Team 5 Design Review

First Design Review with Team 2 - 8:00 pm - 9:08 pm - Meeting Notes:

Figure 1. Figures shared by Team 5.

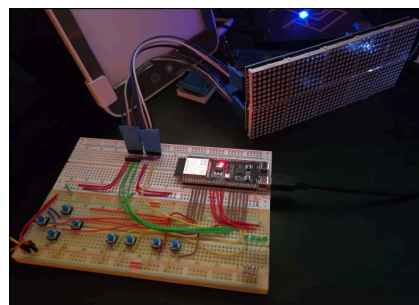
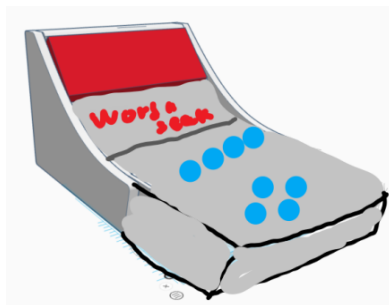
- > Little to no negative feedback. PCB Traces look good. Everything looks straightforward.
- > Positive feedback on the schematic design, with inquiries about its size and potential improvements.
- > Overall comment: "Good job!"
- > Suggested to add switch main power rail.
- > Should have 1uF labeled on decoupling cap on ESP32S3.
- > Should add a note about having onboard USB on dev board.

- > Voltage threshold 1.2 volts.
- > Suggested labeling screen dimensions directly on the schematic for clarity and reference.
- > Suggested labeling buttons on the schematic; e.g., ☐ Adding "boxes" (label above buttons)
- > Add test points to the schematic??

- GND should be labeled with 1.5 Farad (note for Bucanan).
- Label onboard USB for the PCB (also note for Bucanan).
- Overall no negative feedback, keep up the good work.
- Everything is straightforward, nothing extra or unnecessary.
- The on/off switch can be added directly to the PCB.
 - However, Daniyl will stick with designing a separate circuit for testing purposes.

- Power distribution needs more defining.
- The threshold is 1.5V.
- Add a label above the buttons (recommended by Annika).

Figure 2. Figures shared by Team 2

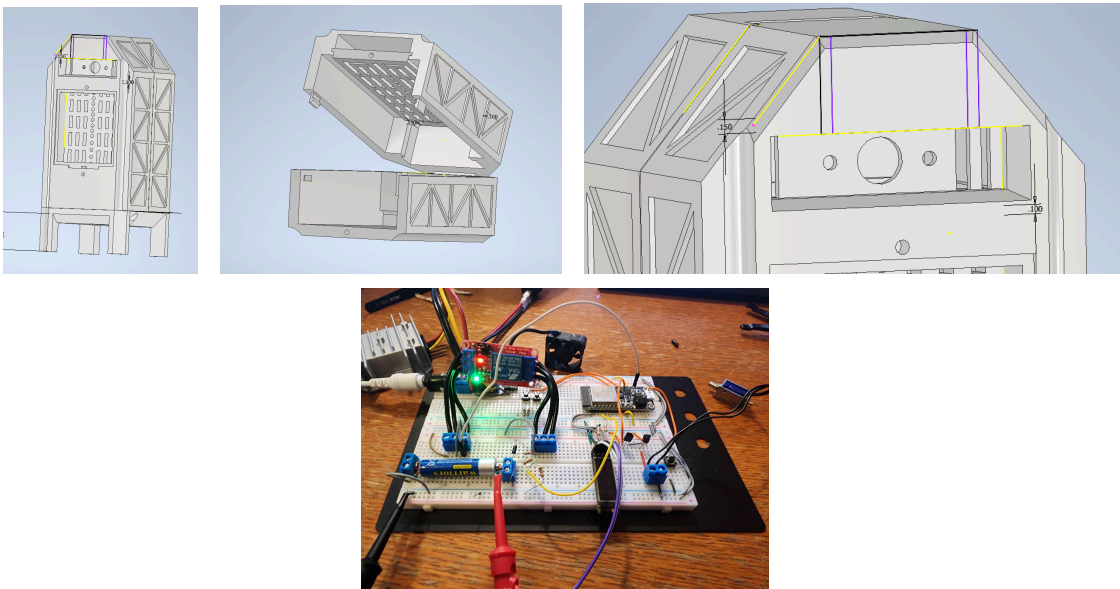
- Pretty clear schematic to look at and ready.
- Specific roles defined. Every member seems caught up on the design and their own parts.
- The team also ran into plenty of problems, like proper power distribution.

- Resolved everything properly.
- Safeguards put into place like a power-off state in case of current issues.
- OLED ground makes sense, something else Buchanan found does not.

- Another OLED bit referenced questionably (NOT AN ISSUE).
- The battery can only be charged twice or three times.
 - Systems are put into place to check fresh batteries against garbage batteries.

- Buchanan recommended adding fuses or Zener diodes to ensure proper 12 Volt flow (??)
- Last note: the buck converter handles most of the voltage regulation.

- The fan is always on. As long as the master switch is closed, the fan is on (always).
- It takes a couple hours to charge a battery (estimated 2 hours).

- You cannot push a battery too much while charging it, as it might break.
- Active high input. For safety, if the ESP32 fails, the active high input goes down.

- Recommendation by Buchanan: Implement a hardware failsafe.
 - (exclusively software failsafes implemented now).
- List V_{TN} for the transistors. Rename schematic ports for clarity.

- Add a current limiting diode between VCC and sensitive components.
